**ADDENDUM #2
PHASE 4 PRIMARY UPGRADES AT
DELAWARE HOSPITAL f/t CHRONICALLY ILL
100 SUNNYSIDE RD., SMYRNA DE 19977
DHSS/DFM PROJECT NO.: MJ3514000013
DATE OF ISSUE: 1/22/2015**

1.0 This Addendum, Addendum No. 2, shall be made part of the Project Manual and Drawings dated January 5, 2015 for the Phase 4 Primary Upgrades at Delaware Hospital f/t Chronically Ill.

4.3 Drawing E-5A:

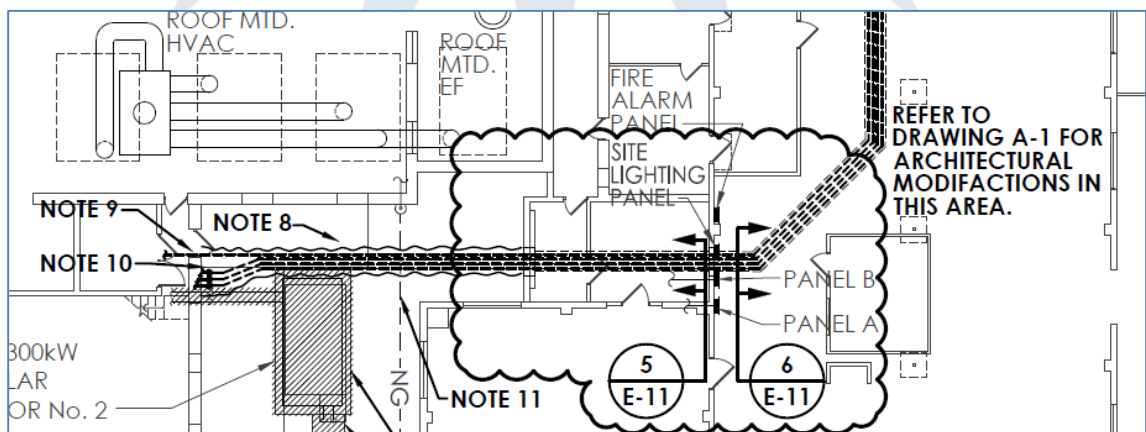
A. Revise ductbank details to ductbank through building as shown below:

4.4 Drawing A-1:

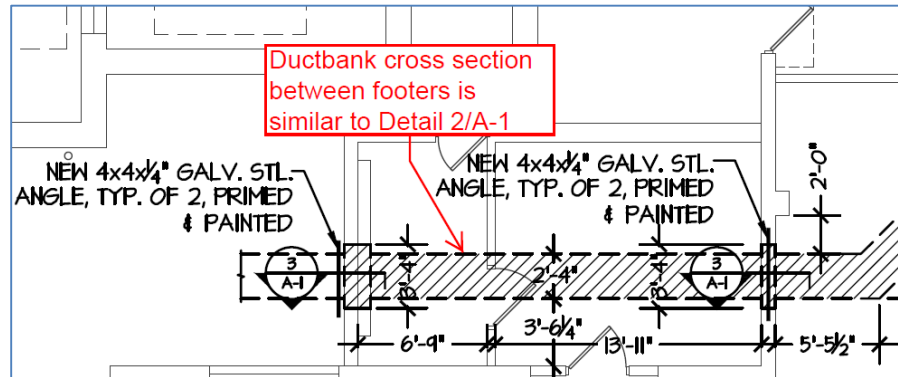
- A. Revise designation of ductbanks where ductbank runs left to right on plan through two (2) interior rooms similar to Detail 2/A-1.
